CPC - ALTON RD
1801 ALTON RD.
MIAMI BEACH, FL 33139

ADDENDUM C - PLAN REVIEW RESPONSES

JPM Chase - Alton Road
CPC Interior Renovations
1801 Alton Road
Miami Beach, Florida

PARTIAL FLOOR PLAN - NEW
SCALE 1/4"=1'-0"
2

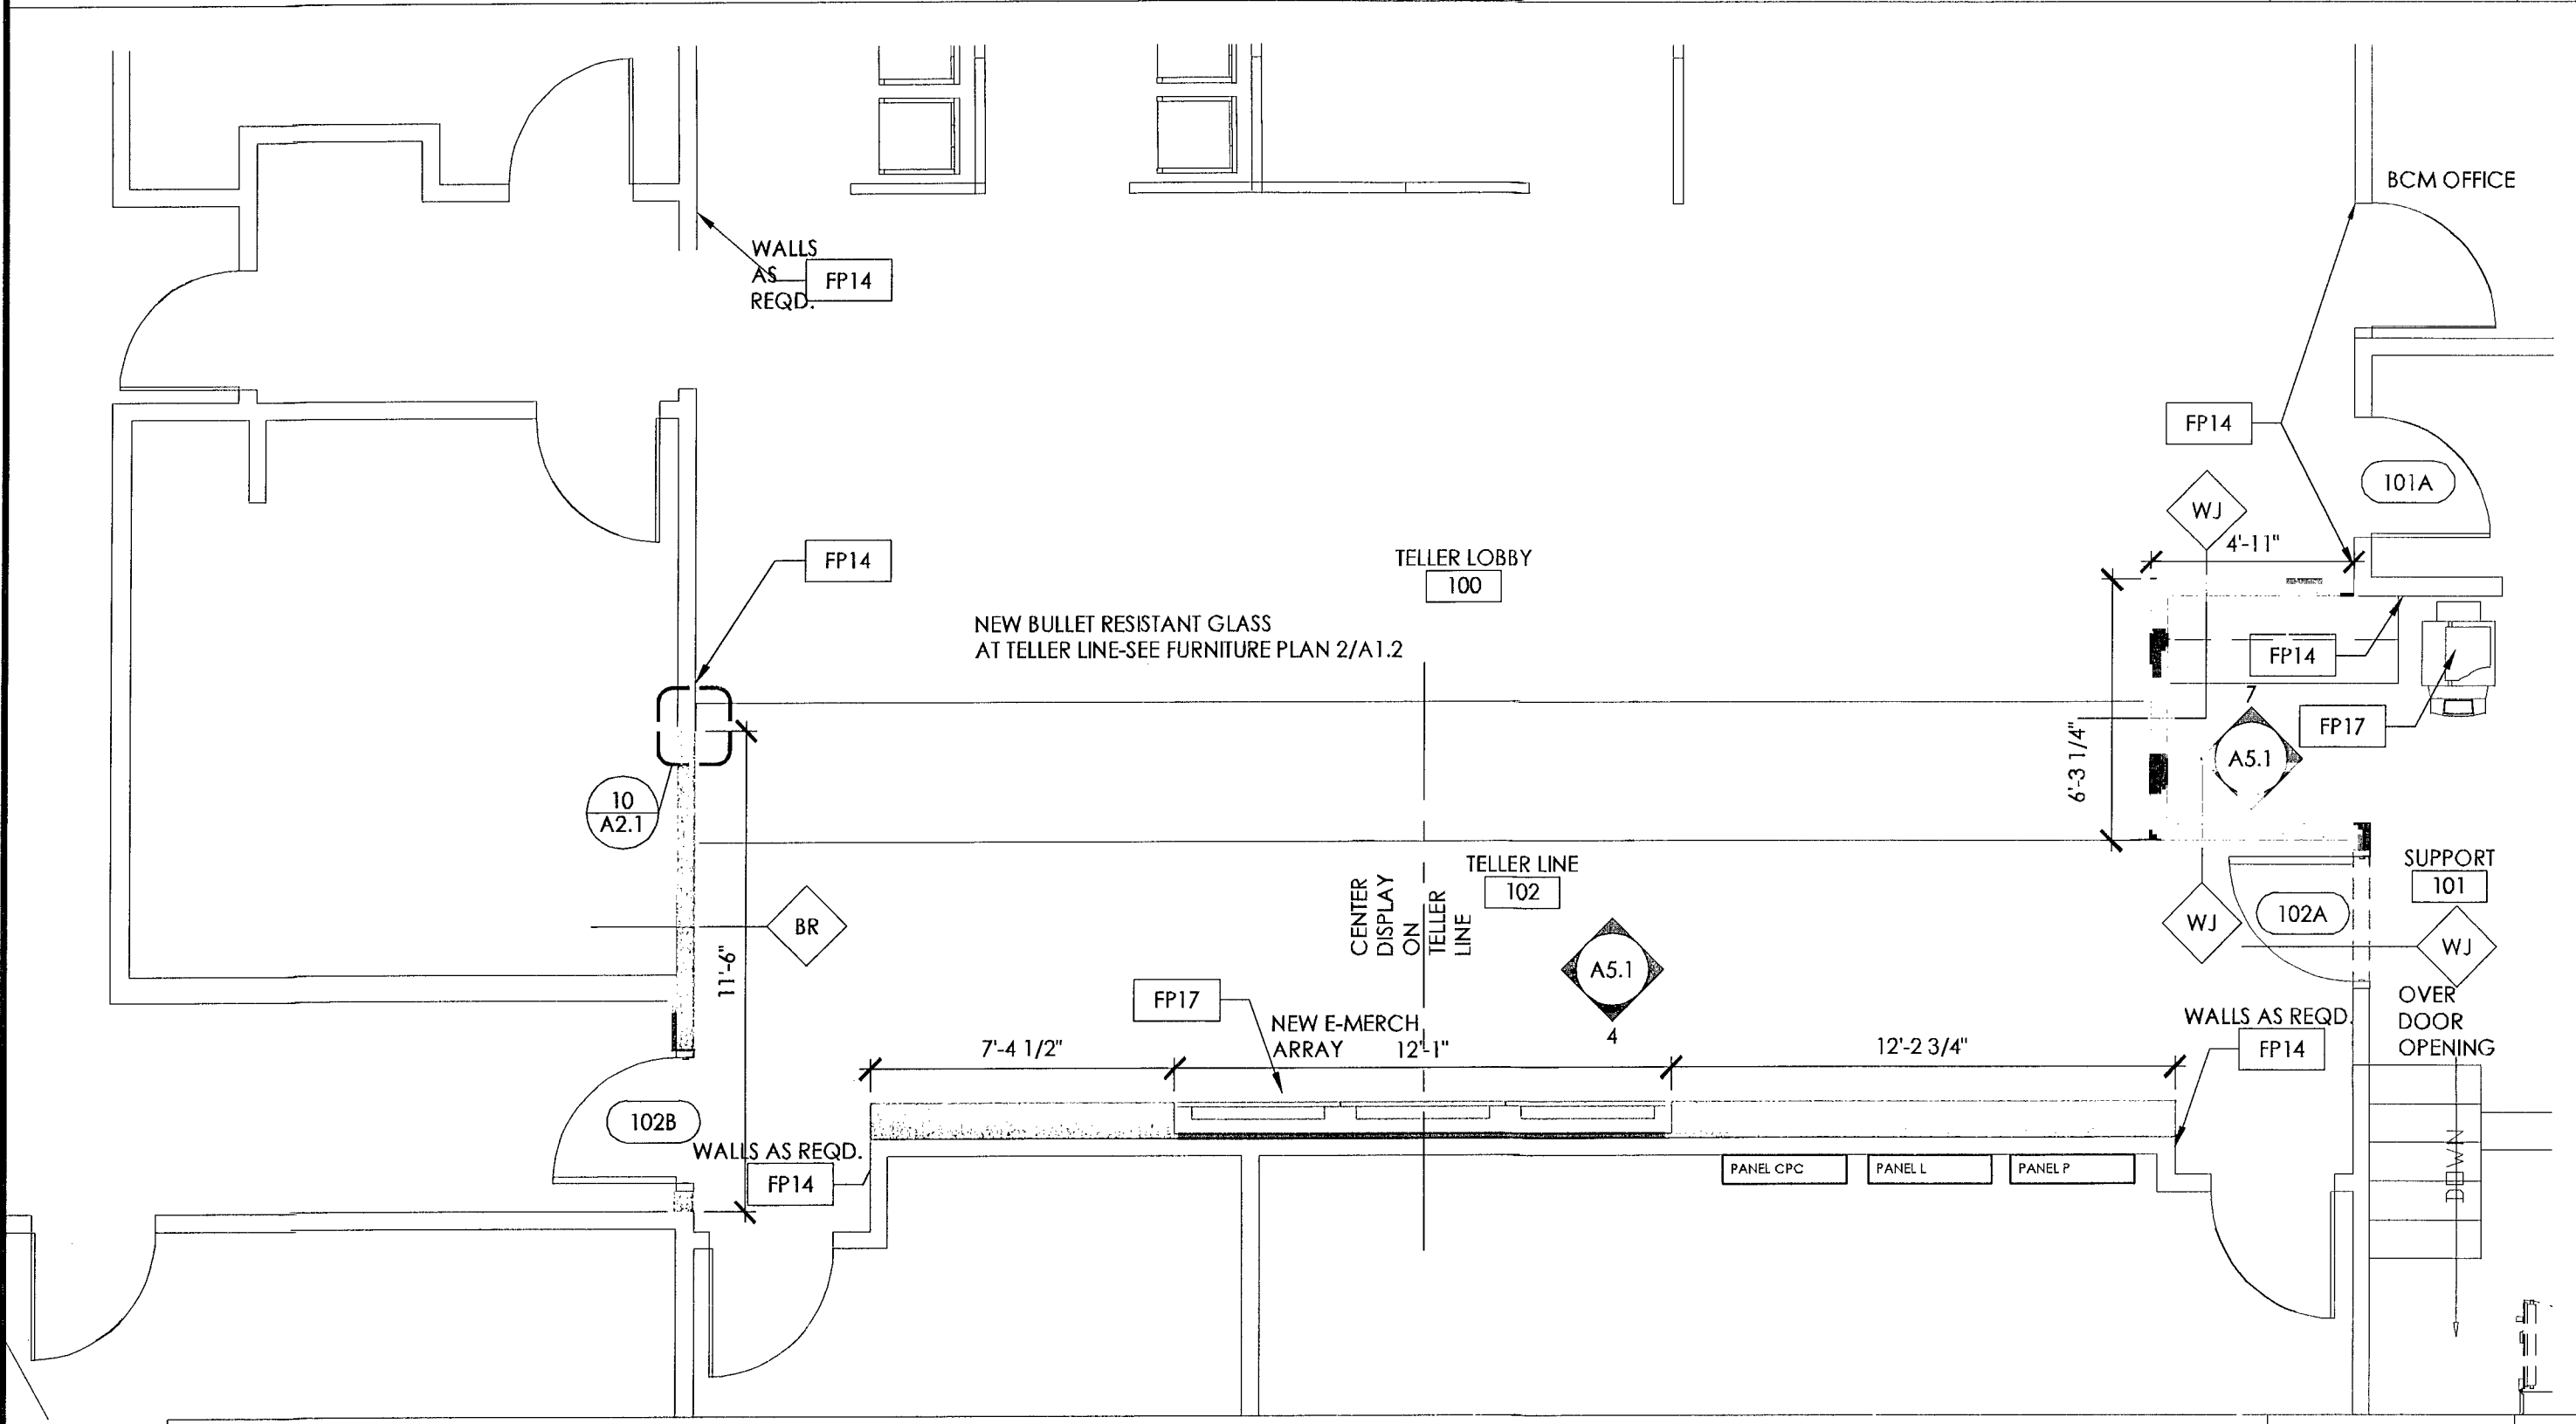
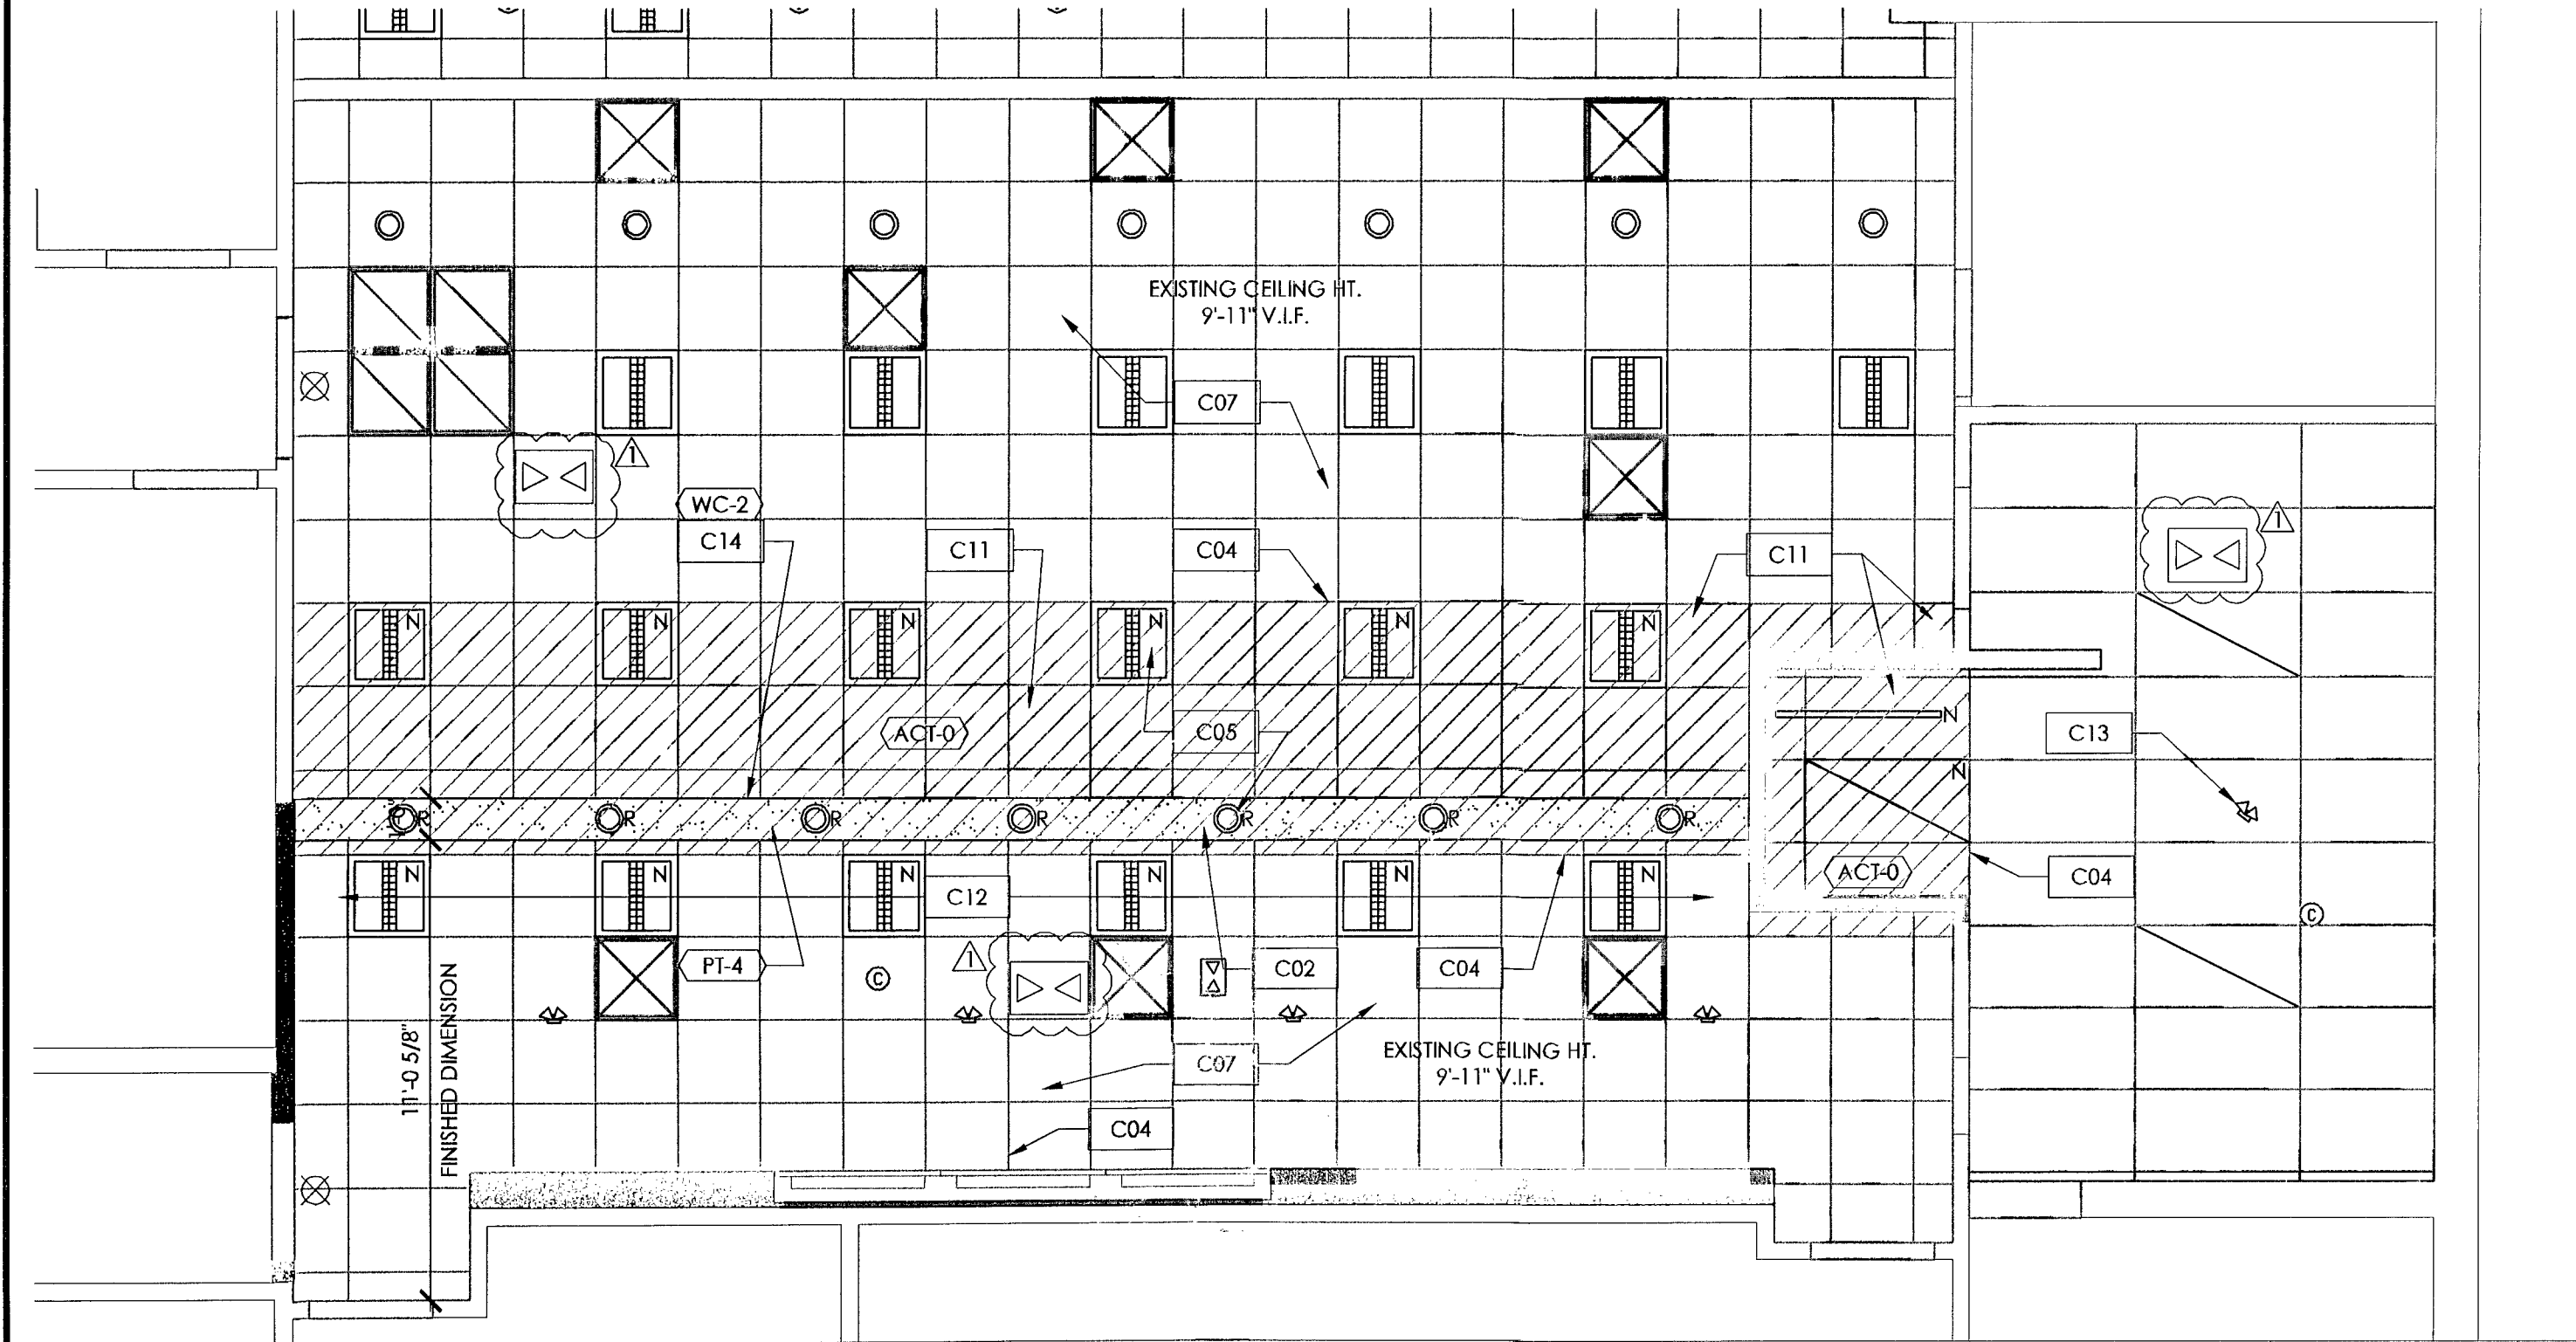
6. **Sheet A1.2: Comfort zones: Provide 36" accessible furniture clearance and provide carpet requirements to comply with FAC §302.2.**
RESPONSE: Please refer to attached revised sheets A0.0 & A1.2 for accessible clearance and carpet requirements.

5

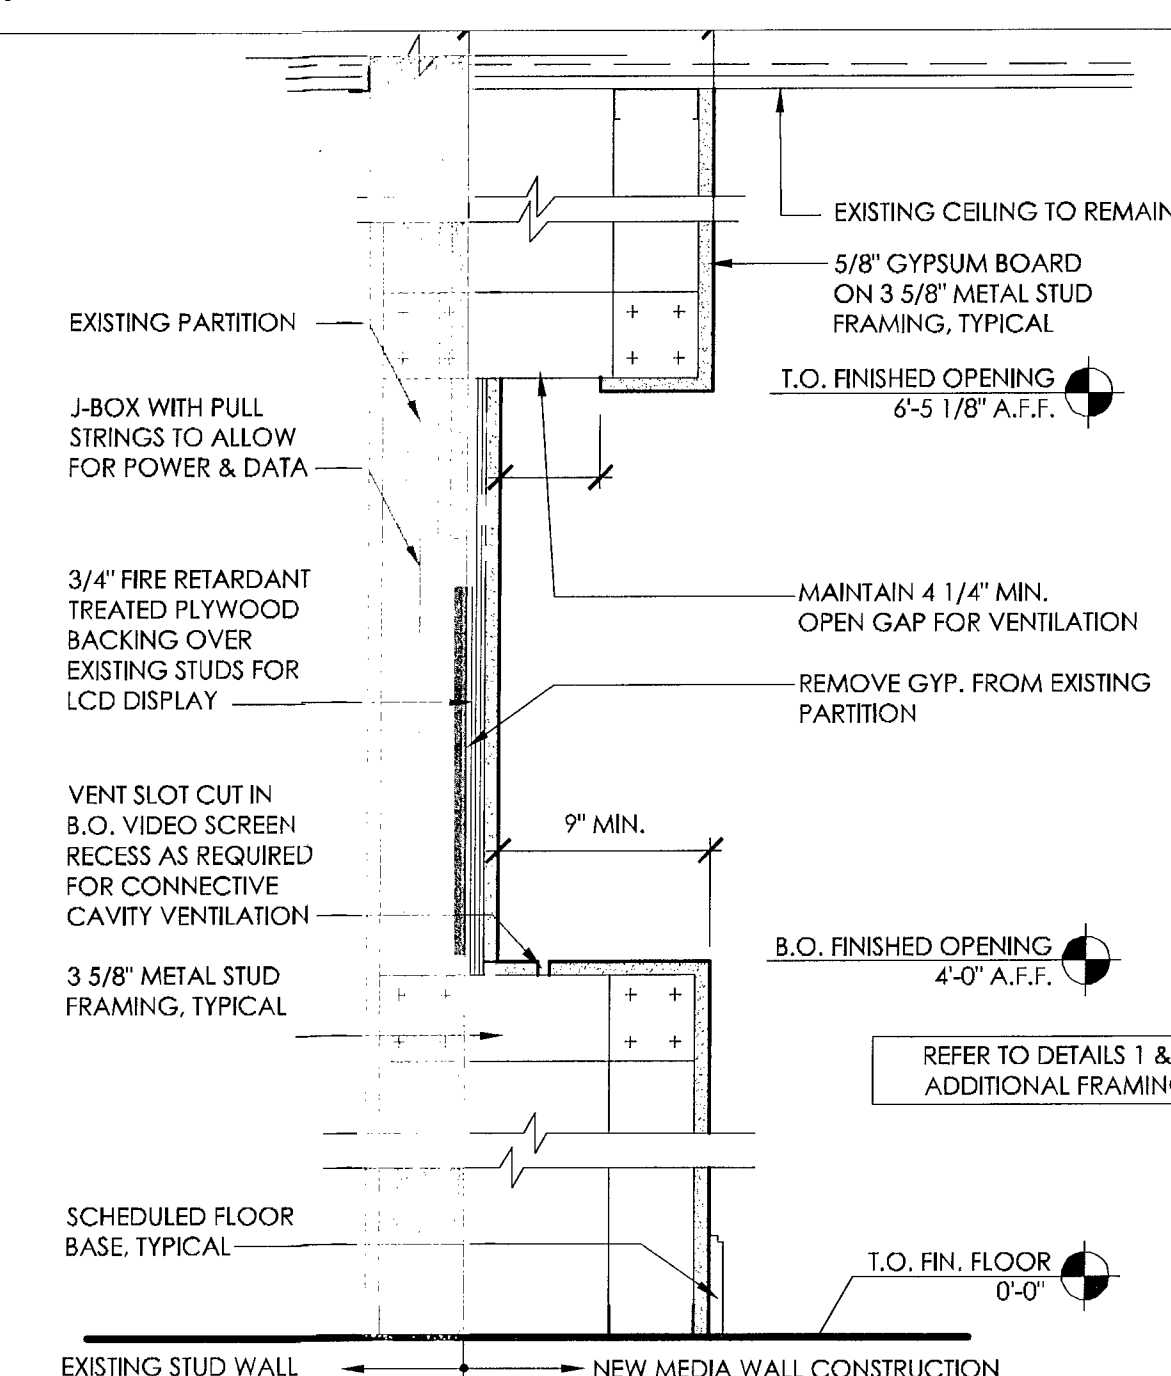
10. **Section 5/A5.1: Provide bottom of counter knee clearance dimension, 27" minimum, per FAC §306.3.**
RESPONSE: Please refer to attached revised sheet A5.1, detail 5, for requested information.

11. Section 5/A5.1: Provide 25" maximum reach dimension, suggest reduce 1'-9" dimension to 1'-1" to comply with FAC §308.2.

SCHEMATIC CEILING SECTION SCALE 1/2"=1'-0" 8

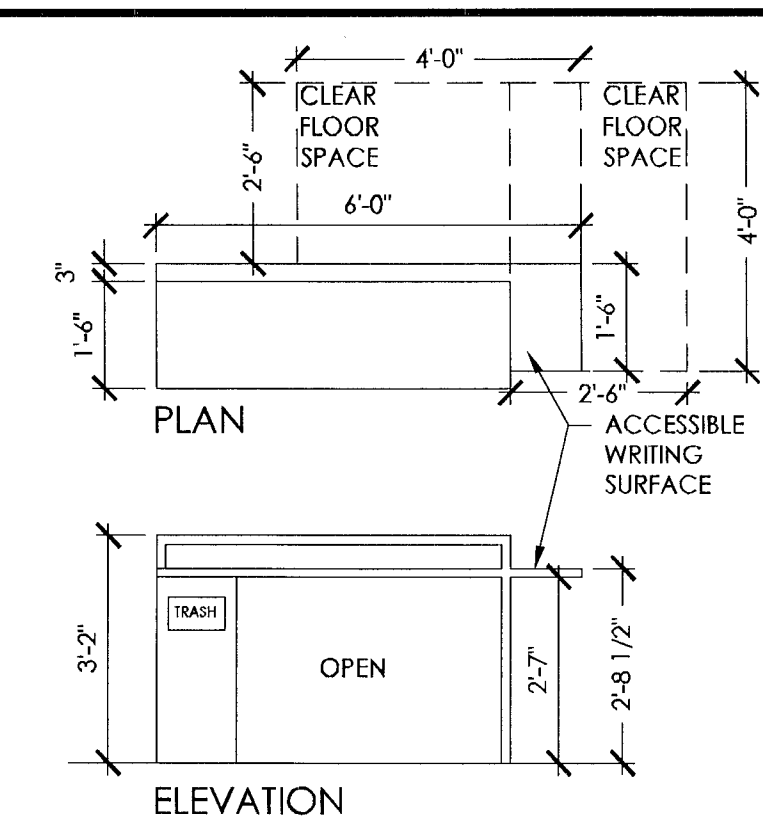
2. **Sheet A0.0: Provide number of stories of building. Clarify if floor ceiling assembly over work area is a fire rated separation for occupancy above. If so, on plans provide a cross section and a UL detail (or equal) for the fire rated floor-ceiling assembly in compliance with FBC chapter 7.**

RESPONSE: The existing building has two stories. As per telephone discussion between Mr. Schaad (City of Miami Beach) and Caleb Janus (BDG Architects) on March 25, 2013, on-site investigations have been made, which indicate that the construction of the floor/ceiling assembly is poured concrete slab on poured concrete beams. As discussed, it is not possible to determine the exact nature of the materials and thickness of the structure. However, the existing floor / ceiling assembly is not being altered or affected in any way by the proposed renovation. Please refer to attached revised sheets A0.0 & A5.1 detail 8, for a schematic section of the existing condition as requested.
